SERVICE BULLETIN

BULLETIN NO: AM-466-TLH

EQUIPMENT: AMS-G1 Stereo Generator

SUBJECT: Pilot Crystal Circuit

HARRIS
STEREO GENERATOR
992-8845-001
843-5429-002
REV F

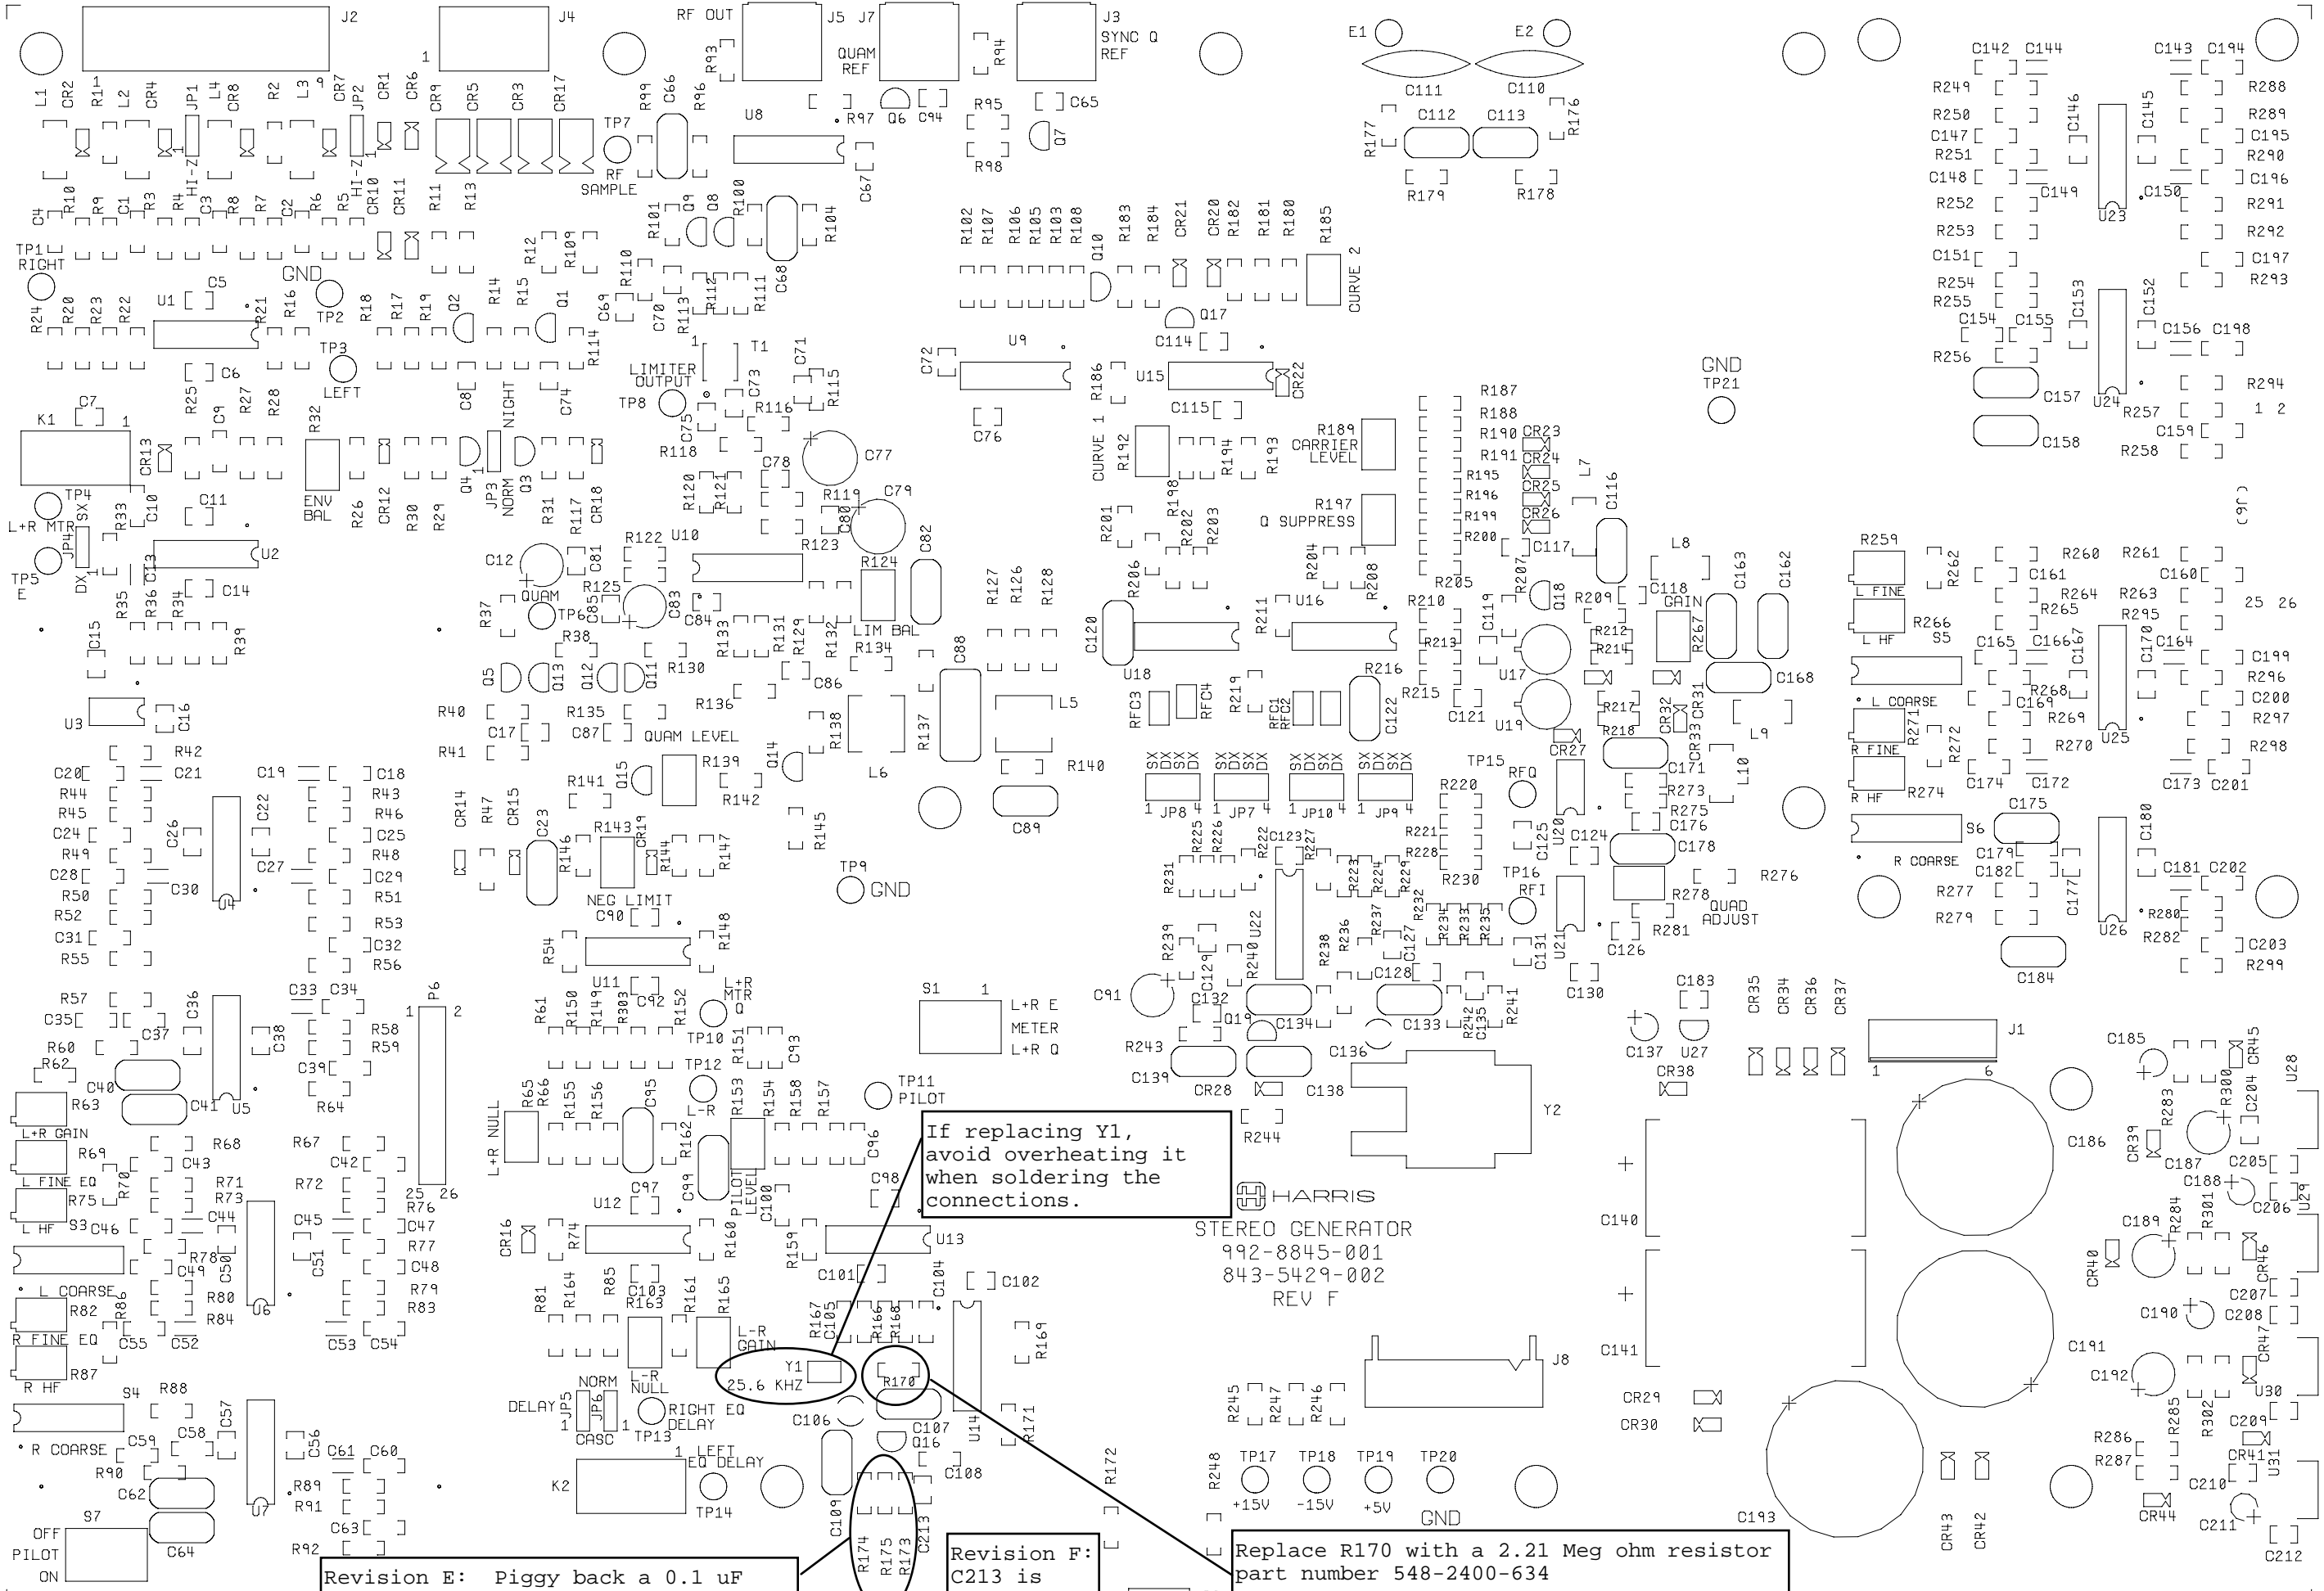
If replacing Y1, avoid overheating it when soldering the connections.

Revision E: Piggy back a 0.1 uF capacitor C213 516-0453-000 across R175.

Revision F: C213 is standard.

Replace R170 with a 2.21 Meg ohm resistor part number 548-2400-634

DRAWN BY	DWC	TITLE	SCHEM. STEREO GENERATOR	
DATE	3-25-93	DWG #	839-8138-002	REV H
ENG CHK	RLB	SHEET	5	OF 7
PROJ ENG	DWC			
MFG ENG	S. CORNWELL

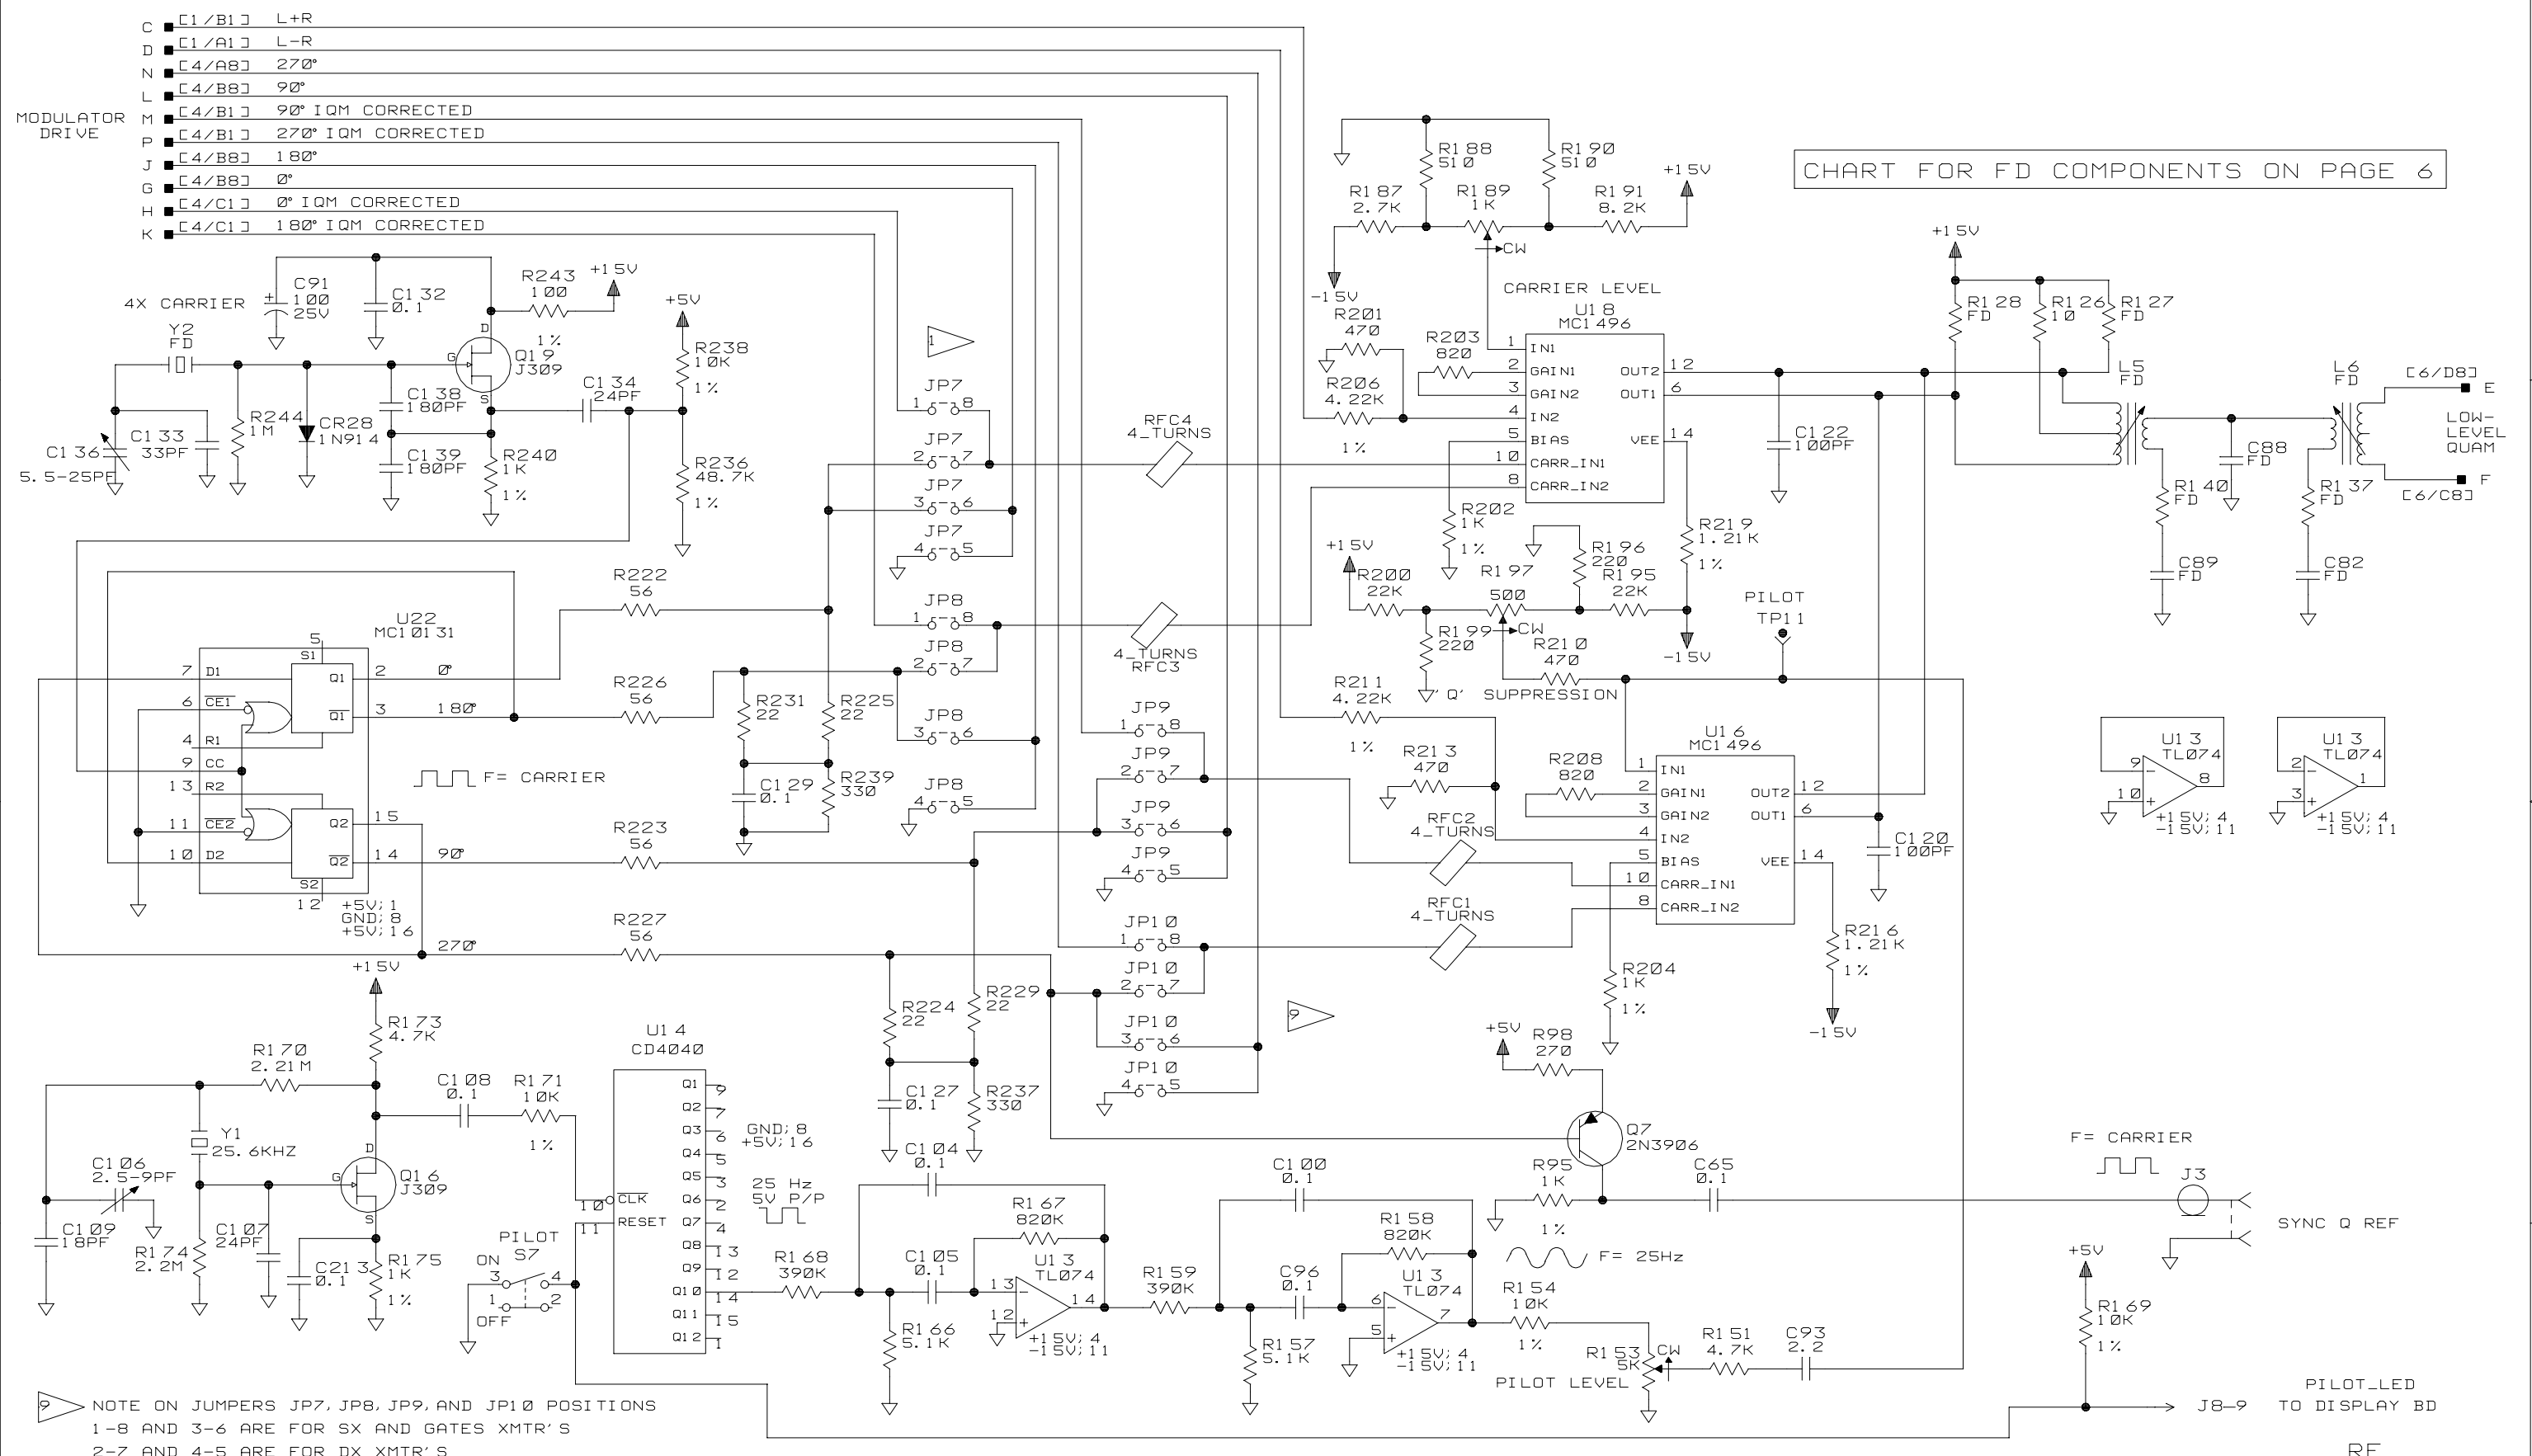
NOTES	4. INDUCTANCE IN UH.	REVISION	LTR	ZONE	DATE	DFTM	ENG	ECO NUM	
	3. CAPACITANCE IN UF.		G		05-14-97	DFD	.	41332	
	2. RESISTANCE IN OHMS.		ADD C213, REV R170						
	1. ALL RESISTORS ARE 1/2 WATT, 1%.		H		2-1-00	DFD	DFD	45075
